# Project Proposal

Property Address 9210 N Pelham Pkwy

Attention:  
Village of Bayside, WI  
Architecture Review Committee

## VILLAGE CODE REVIEW

# A PLAT OF A SURVEY

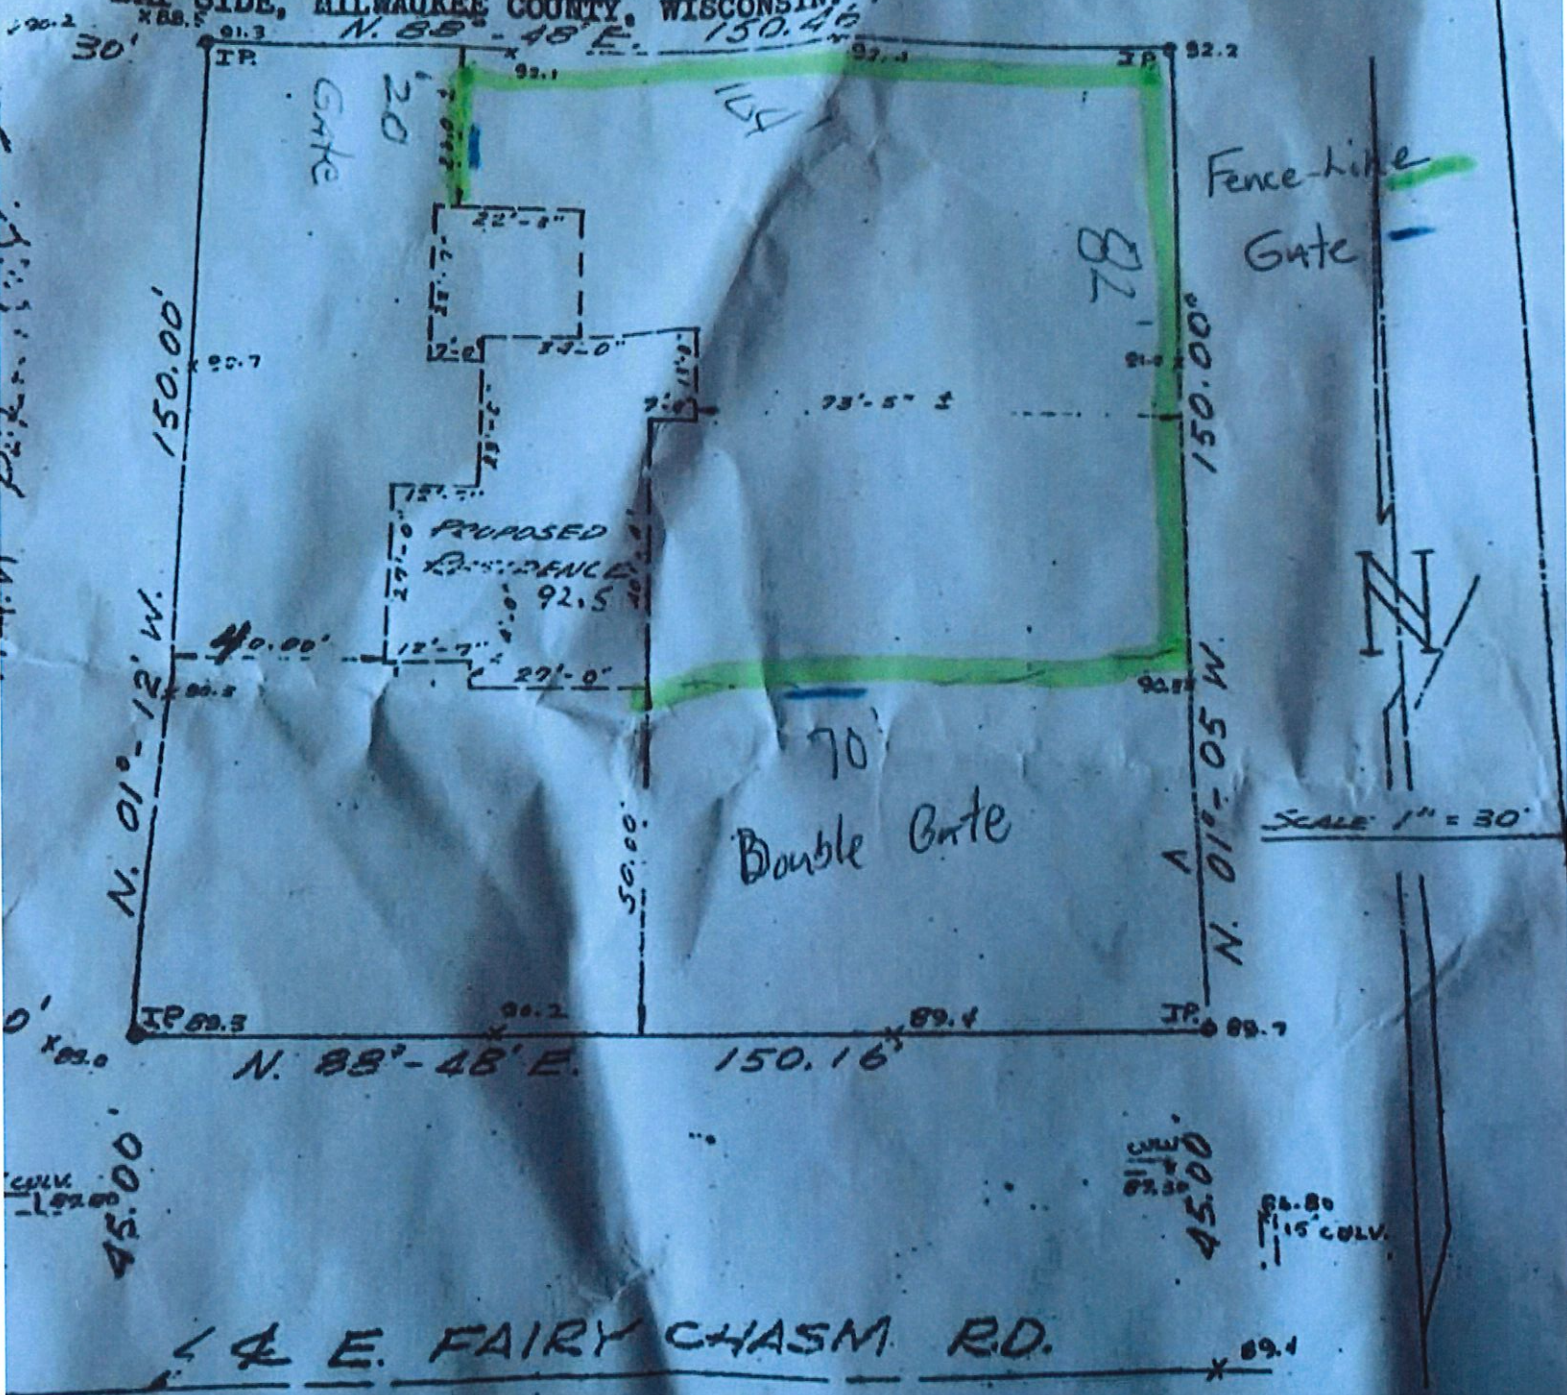
**Note: The measurements of the fence must be based off of the over lay on the survey Page 10 and not the hand drawn sketch**
